128. Physical Medium Dependent sublayer and baseband medium, type 2.5GBASE-KX

130. Physical Medium Dependent sublayer and baseband medium, type 5GBASE-KR

Figure 128-4—Transmitter differential mode return loss

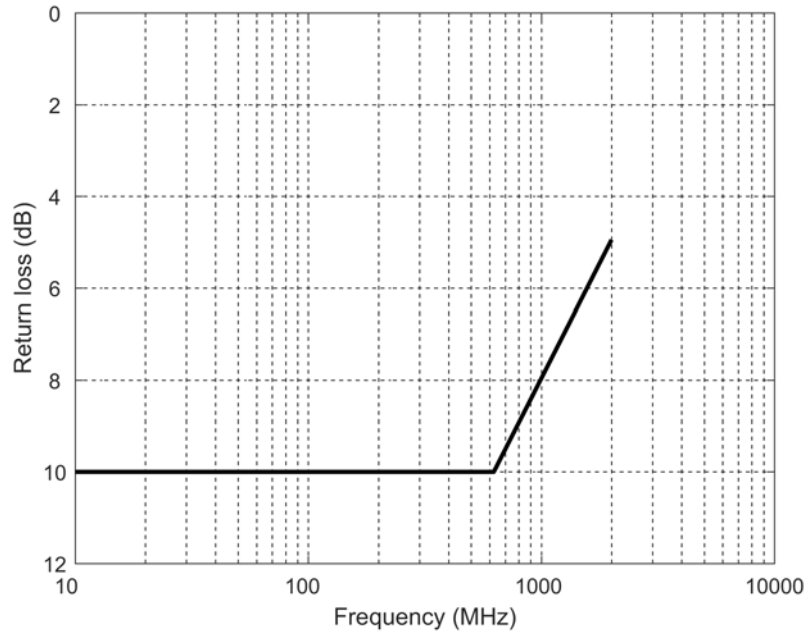
For frequencies from 100 MHz to 2000 MHz, the differential return loss, in dB with f in MHz, of the transmitter shall meet the requirements of ~~Equation (128-3) and Equation (128-4)~~. This output impedance requirement applies to all valid output levels. The reference impedance for differential return loss measurements shall be 100 Ω .

Figure 128-5—Transmitter ~~common~~**differential** mode return loss

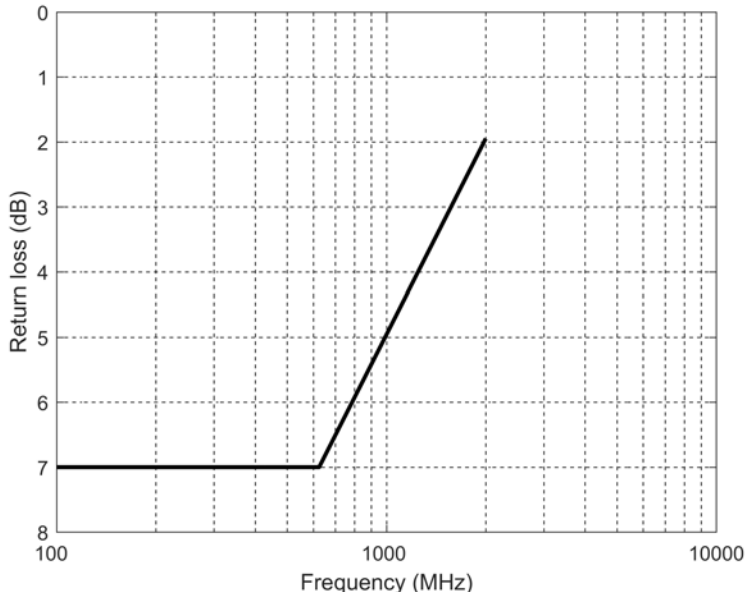
The transmitter common-mode return loss shall meet the requirements of ~~Equation (128-5) and Equation (128-6)~~. The reference impedance for common-mode return loss measurements is 25 Ω.

The minimum ~~common mode~~ differential output return loss is shown in Figure 128-5.
